Access Compliance Report

Public Rights-of-Way

(Curb Ramps)

Intersection ID: 28305	Main Street: COMMUNITY HOUSE RD	Cross Street: TAMARRON DR	Location: W
ADA ID: 52D214C83BB0	Ramp Type: Perp	Initial Pass/Fail: Fail	Overall Compliance: No
Codes/Mitigation Info/Possible Solution		Field Measurements/Component Compliance	
Severity Score: 21.25

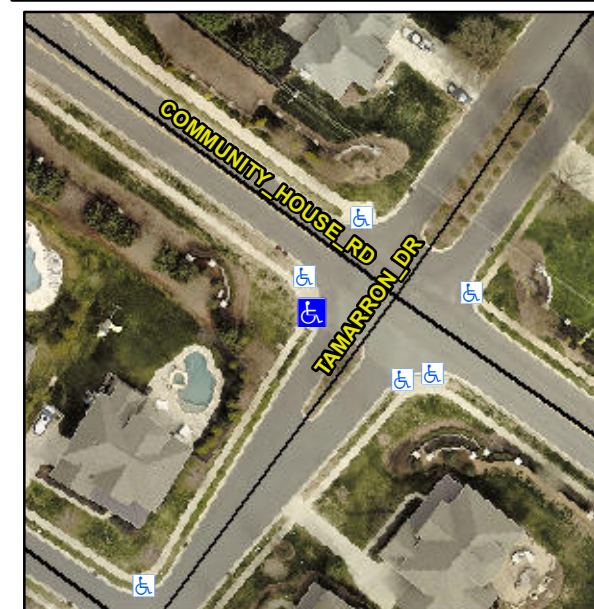
Not Found, R304.5.1, R304.5.3

Compliance	Description	Data	Compliance	Description	Data
N/A	Ramp Length (in)	51.0	Yes	Ramp Slope (%)	7.7
No	Ramp Width (in)	47.0	No	Ramp XSlope (%)	5.5
N/A	Flare Type LT	N/A	N/A	Flare Type RT	N/A
N/A	Flare Slope LT (%)	N/A	N/A	Flare Slope RT (%)	N/A
N/A	Flare Traversable LT?	N/A	N/A	Flare Traversable RT?	N/A
N/A	Landing Length (in)	N/A	N/A	DWS Provided?	N/A
N/A	Landing Width (in)	N/A	N/A	DWS Contrast?	N/A
N/A	Landing Slope (%)	N/A	N/A	DWS Length (in)	N/A
N/A	Landing X Slope (%)	N/A	N/A	DWS Full Width?	N/A
N/A	Landing Curb? (Y/N)	N/A	N/A	DWS Offset (in)	N/A
N/A	Shared Landing?	N/A			
N/A	Gutter Ponding?	N/A	N/A	Gutter Slope (%)	N/A
N/A	Gutter Lip Ht (in)	N/A	N/A	Gutter X Slope (%)	N/A
N/A	Painted X Walk1?	No	N/A	Painted X Walk2?	N/A
	X Walk 1 Direction	To SE		X Walk 2 Direction	N/A
N/A	X Walk 1 Width (in)	N/A	N/A	X Walk 2 Width (in)	N/A
	X Walk 1 Slope (%)	3.8		X Walk 2 Slope (%)	N/A
	X Walk 1 X Slope (%)	7.4		X Walk 2 X Slope (%)	N/A

Remove & Replace Entire Ramp.
